SUBJECT: SHEARON HARRIS NUCLEAR POWER PLANT, UNIT 1 - ISSUANCE OF  
AMENDMENT REGARDING PRESSURE/TEMPERATURE LIMITS  
(TAC NO. MA8642)

The Nuclear Regulatory Commission has issued Amendment No. 100 to Facility Operating License No. NPF-63 for the Shearon Harris Nuclear Power Plant, Unit No. 1 (HNP), in response to your request dated April 12, 2000, as supplemented on June 2, 2000. This amendment revises Technical Specification (TS) 3/4.4.9.2, "Pressure/Temperature (P-T) Limits - Reactor Coolant System," and TS 3/4.4.9.4, "Overpressure Protection System," and the associated Bases. Specifically, the amendment incorporates results of the Reactor Vessel Surveillance Program capsule analysis and an exemption from 10 CFR 50.60(a), based on American Society of Mechanical Engineers Code Case N-640. The exemption to use Code Case N-640 was previously approved by separate correspondence.

SAFETY EVALUATION BY THE OFFICE OF NUCLEAR REACTOR REGULATION

FIGURE 3.4-2  
 REACTOR COOLANT SYSTEM  
 COOLDOWN LIMITATIONS — APPLICABLE TO UP TO 36 EFY

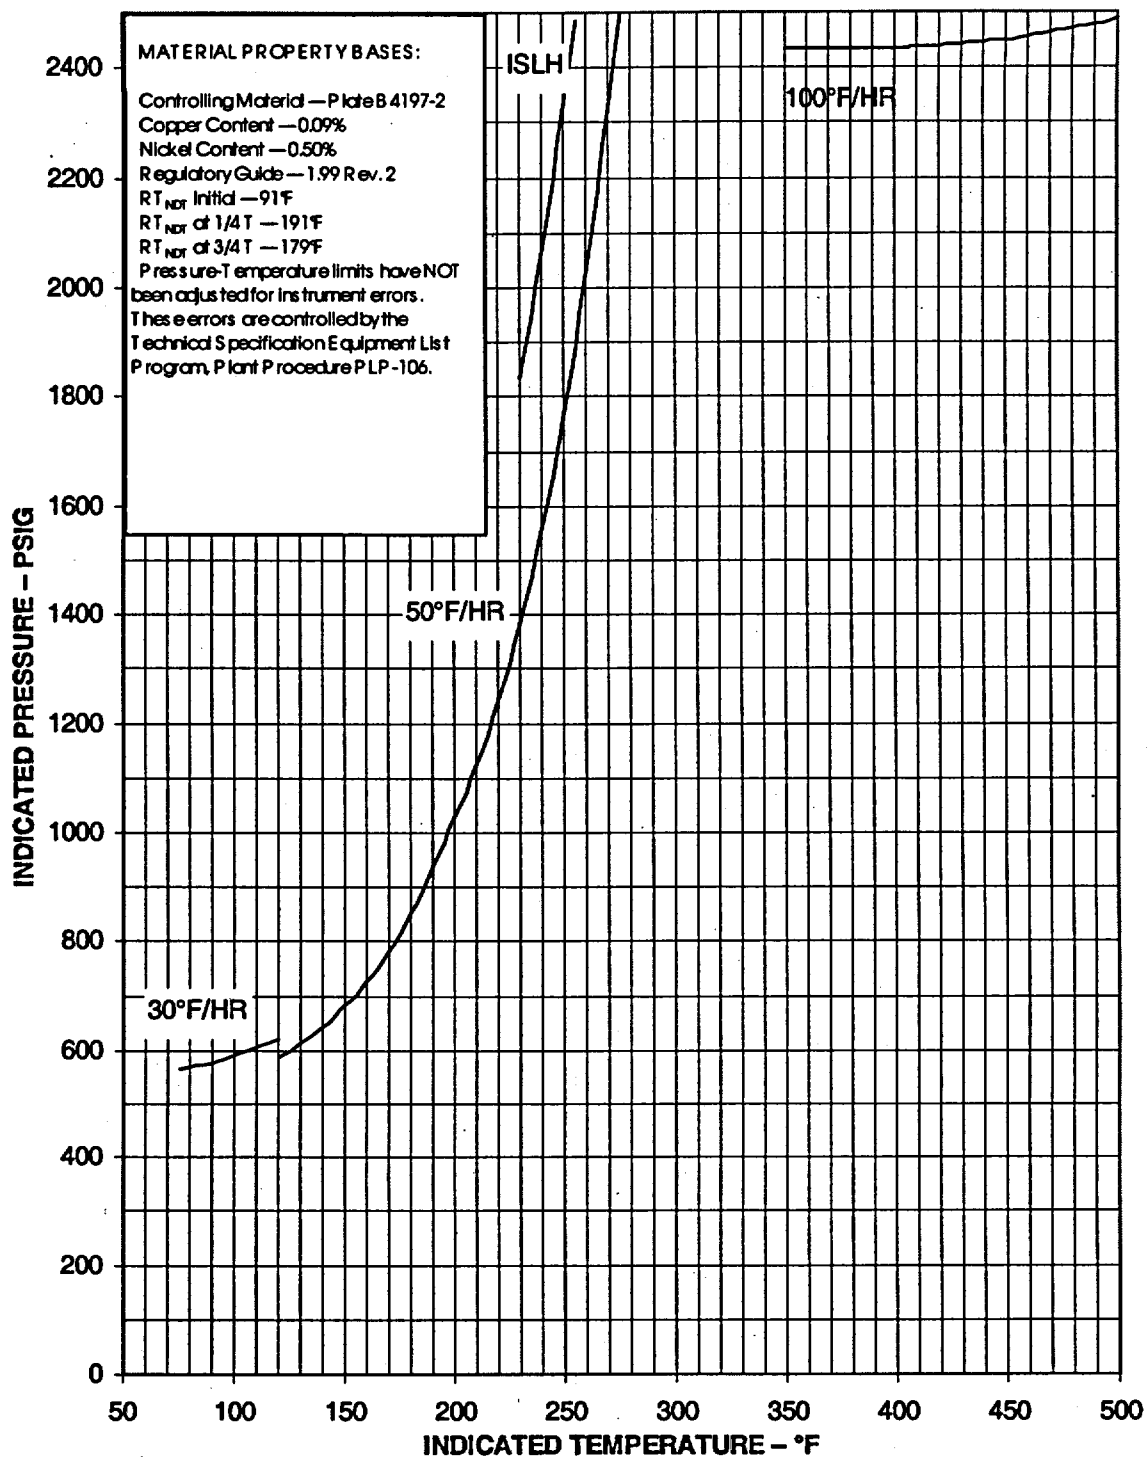
In addition to changing the P-T limit curves as described above, the licensee proposed changes to the cooldown and heatup curves in Figures 3.4-2 and 3.4-3, respectively, and to the power-operated relief valve (PORV) setpoints.

The cooldown and heatup curves in TS Figures 3.4-2 and 3.4-3 are changed to reflect the new limits. The heatup curve is now limited to a single heatup rate of 50°F/hr. The cooldown curve is reduced to two segments of 50°F/hr and 30°F/hr, respectively.

FIGURE 3.4-4

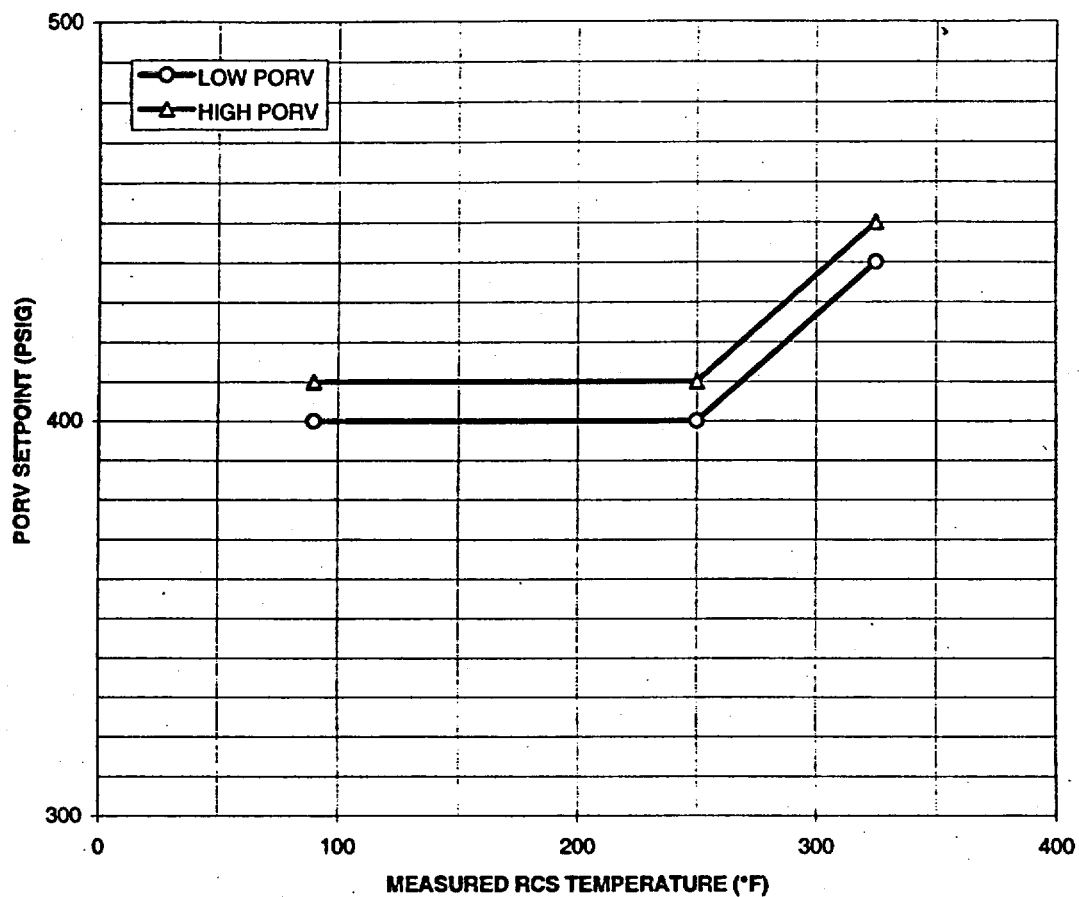
The PORV setpoints are credited for RCS temperatures at or above 90°F. The corresponding PORV settings are: for temperatures <250°F, the setpoints are 400/410 psig low/high, respectively; for temperatures between 250°F and 325°F, the setpoints change linearly from 400/410 psig low/high to 440/450 psig low/high, respectively; for temperatures above 325°F, the pressure can assume any value up to 2400 psig. For heatup between 90°F and 125°F, the new heatup rate is 50°F/hr and the corresponding pressure limit is 563 psig. For cooldown between 90°F and 125°F, the new cooldown rate is 30°F/hr and the corresponding pressure limit is 566 psig. The enable temperature did not change from 325°F.

At the above setpoints, the peak RCS pressure that occurs after the PORV has opened at the setpoint is less than the allowable pressure for the limiting heatup or cooldown transient. This accounts for instrument uncertainties, response times, and PORV flow discharge capacities. The proposed TS changes are, therefore, acceptable.

FIGURE B 3/4.4-1  
FAST NEUTRON FLUENCE (E>1MeV) AS A FUNCTION OF FULL POWER SERVICE LIFE

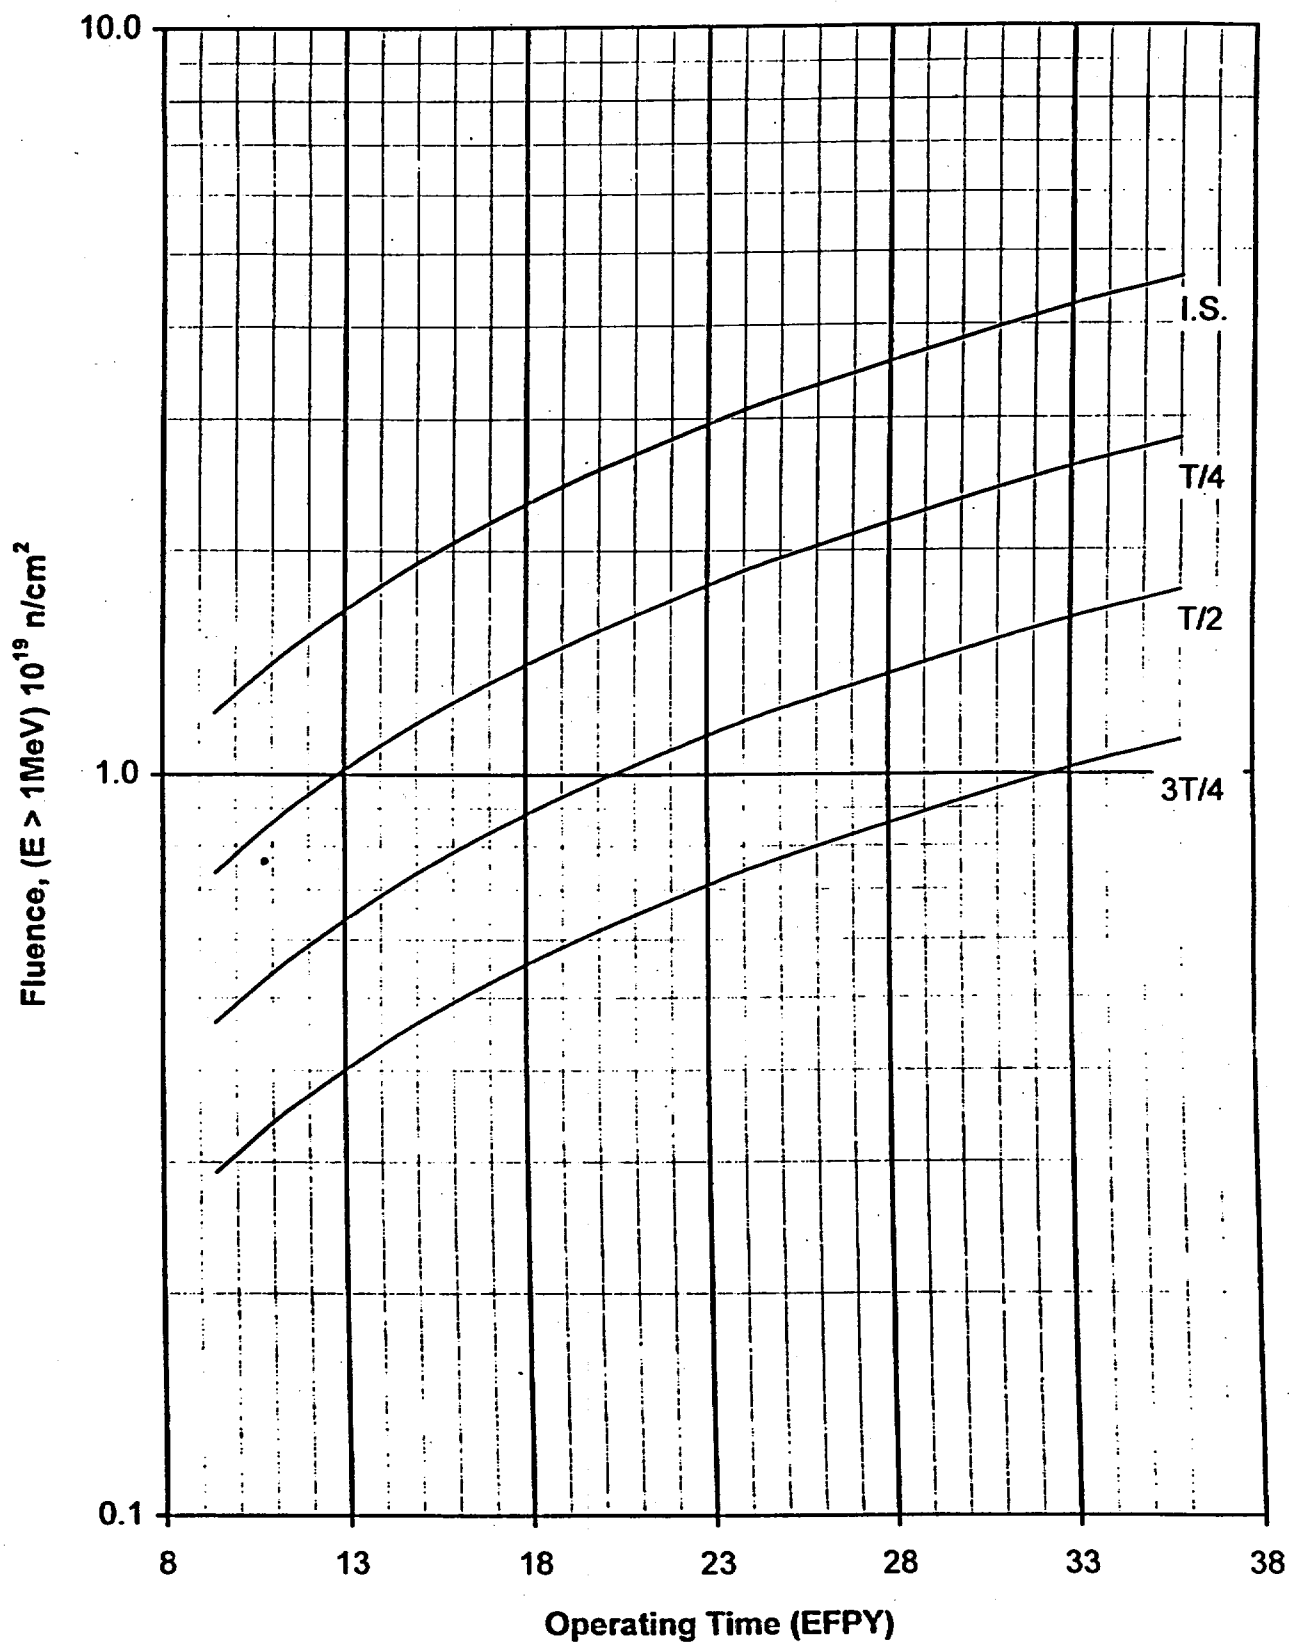
TS Figure B 3/4.4-1 has been replaced to reflect the extended period of operation to 36 EFPY and the surveillance capsule X dosimetry results. These results are also acceptable because they reflect an updated projection of the vessel fluence.
